RE: Major Projects – SEARs Request – 156-166 Rickard Road, Leppington (SSD-84430209)

Below is a summary of the comments that form Camden Council's response to the request for SEARs:

Figure of ILP overlay with proposed road layout

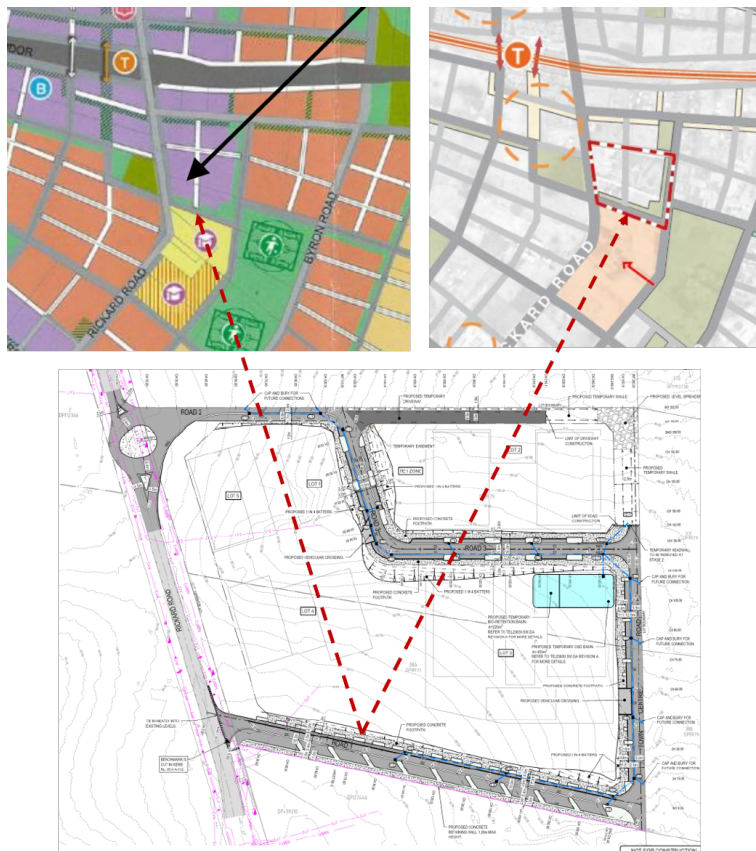
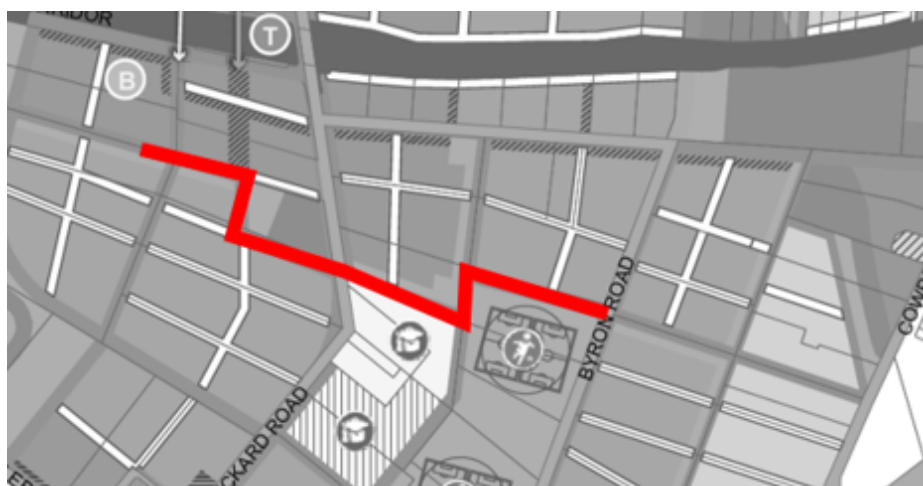
- Council does not support the assumption that Road 1 operates as a one-way road. Road 1 is considered as a key east-west Town Centre Road with two-way traffic movements, providing vehicle access as well as important pedestrian and cycling connection.

A dog-leg arrangement would introduce additional delays and reduced safety for pedestrians and cyclists, particularly school children crossing the intersection. It would also result in limitations to turn bay lengths and sight distances.

- A one-way arrangement would increase travel distances, vehicle delays, pedestrian walking distances and pressure on surrounding intersections. The assessment should be updated to reflect the current road network planning assumptions. In addition to this, Council has expressed concerns regarding the proposed dog-leg alignment of Road 1 to DPHI from the previous perpendicular arrangement at this intersection.

This dog-leg arrangement has potential implications for safety, accessibility, traffic operations and has significant adverse impacts on the ongoing detailed design work and the previous DA approvals.

Council considers the road needs to be straightened with minimal impact on the adjoining open space. Council can work with the proponent to refine the detailed design of this intersection to accommodate full vehicle movements, including right-turn access for school buses, to minimise east-west traffic movements along Byron Road to support efficient bus operations.

Figure 14: Proposed 2041 bus networks through LTCP (Source: TfNSW, March 2021)

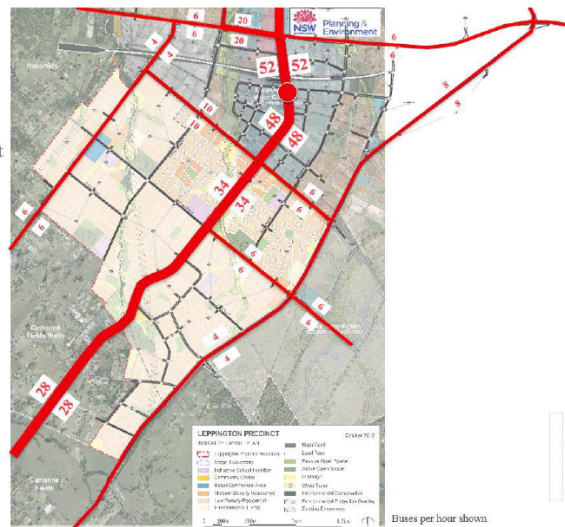
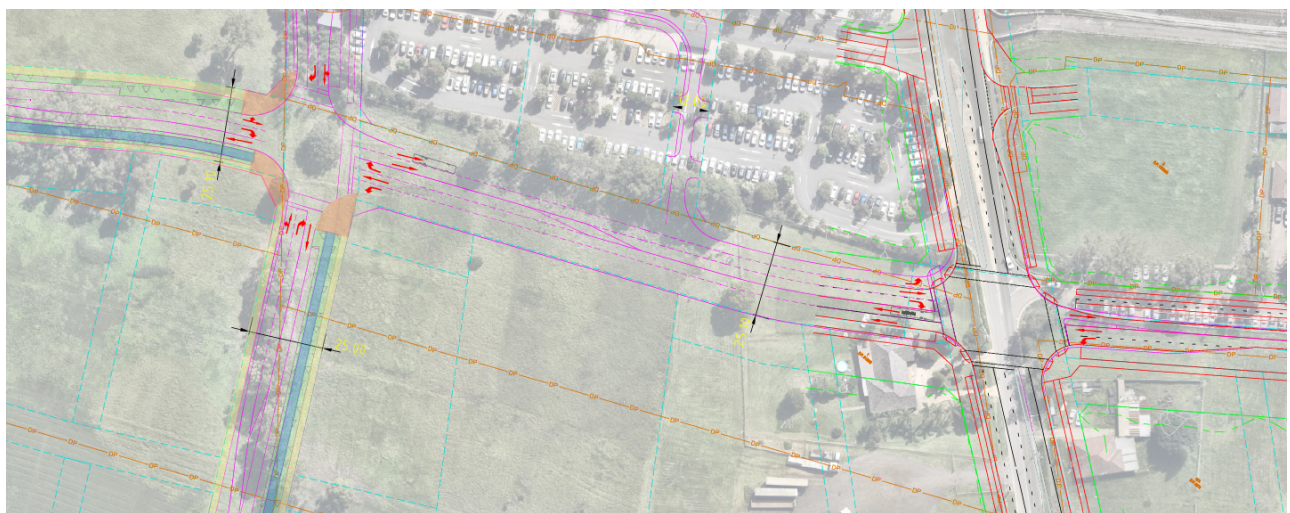
- The assessment has not adequately considered future bus interchange operations and transit corridor requirements. Current detailed design work identifies the Rickard Road and Byron Road intersection as the primary access point to the future bus interchange, which is expected to accommodate approximately 60 bus movements per hour during peak periods (Arup Transport Study, Dec 2022).

- To support these bus movements, the western approach of Byron Road/Rickard Road intersection is likely to require three approach lanes and two departure lanes (refer to the below sketch from the detailed design). These future bus operation requirements should be incorporated into the assessment and reflected in the modelling assumptions. As this intersection is expected to primarily serve bus movements, the traffic distribution assumptions should also be reviewed, with traffic from 173–183 Rickard Road redirected to alternative access routes rather than relying on this intersection as a primary access point.
